RIVERDALE CITY PLANNING COMMISSION AGENDA
CIVIC CENTER - 4600 S. WEBER RIVER DR.
TUESDAY – APRIL 25, 2023

1. Consideration of Preliminary Site Plan request for Tesla Riverdale, located at approximately 4851 South 1500 West, Riverdale, Utah 84405, as requested by 6S Development, LLC and AWA Engineering.

Preliminary Site Plan Review: Tesla Riverdale, 4851 South 1500 West

Attn: Mike Eggett, Community Development Director/RDA Deputy Executive Director
Proj: **Tesla Riverdale**
Subj: Preliminary Site Plan Drawings & Plat Review

12 Orifice Plate Detail

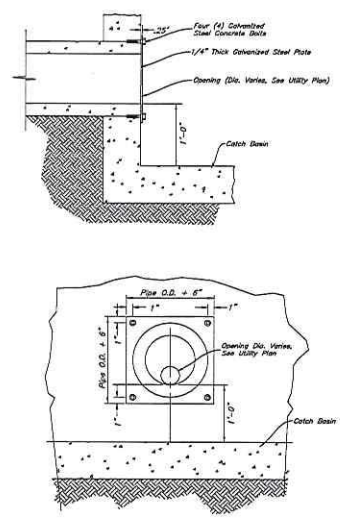
5. There is a detention basin shown in the southeast corner of the property. There is no control on discharge and/or treatment for storm water before it discharges into the city storm water system, please provide.
